The reconstruction of King's Wharf, Suva, Fiji

J. A. Williams, M.I.C.E., M.I.Struct.E., M.Cons.E.

Partner, Messrs Sandford, Fawcett, Wilton & Bell, Consulting Engineers, London

FIG. 15: MR BULLEN'S REDRAWING OF FIG. 6

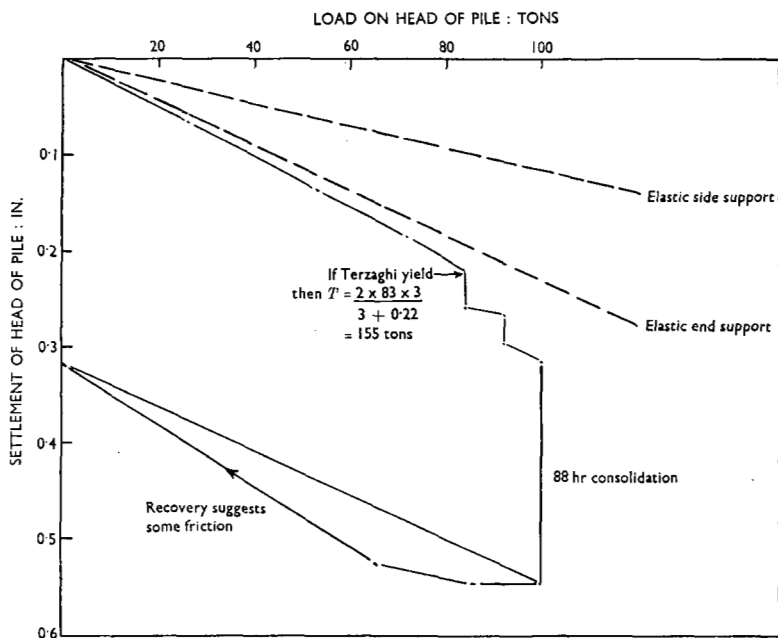
87. He had ventured to re-draw part of Fig. 6 (Fig. 15) in a way which he found easier to follow. This diagram seemed quite normal for a partially tested pile. If the pile were considered as having been entirely supported at the toe, with no friction around it, and the load were applied at the head, the movement of the head would be in the following form added to the diagram. If, on the other hand, the pile was entirely supported by friction, then the movement of the head would be as shown in the diagram.

88. The recovery would be seen to have taken place along the line indicated in the diagram, so that he concluded that the pile was behaving as if supported almost entirely at the toe and only partly by friction. This conflicted with the calculation made previously.

FIG. 16

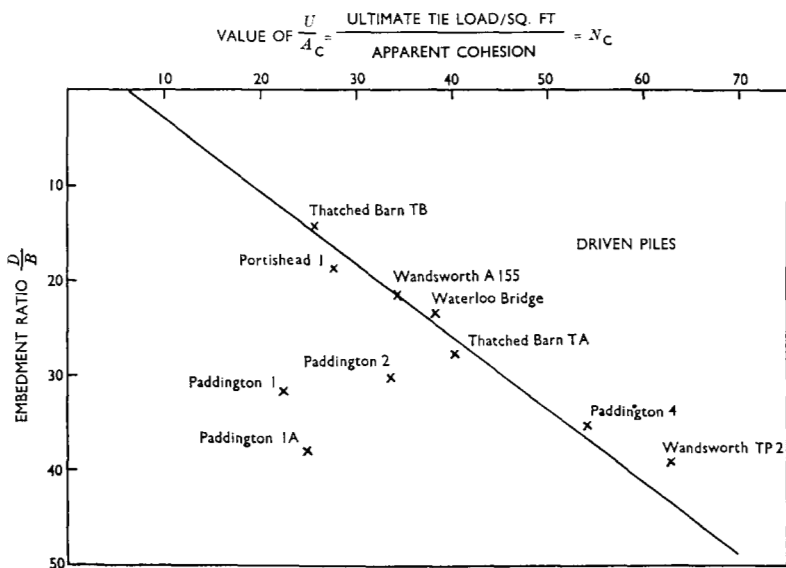
90. On the piles that were being discussed (Fig. 16), taking the embedment length over the diameter, he found that N_c was about 50 (he was sure this was wrong by all the soil mechanics arguments, but this was what one found by experience). Taking this value the toe value would be about 120 tons, and if one could then offer the suggestion that the average friction or adhesion on the piles would be about 0.1 ton, or 2 cwt/sq. ft (the sort of friction one would think of in sinking a caisson or something like that), one obtained 70 tons or so in friction, so that there was a total value for the pile of 190 tons at ultimate.
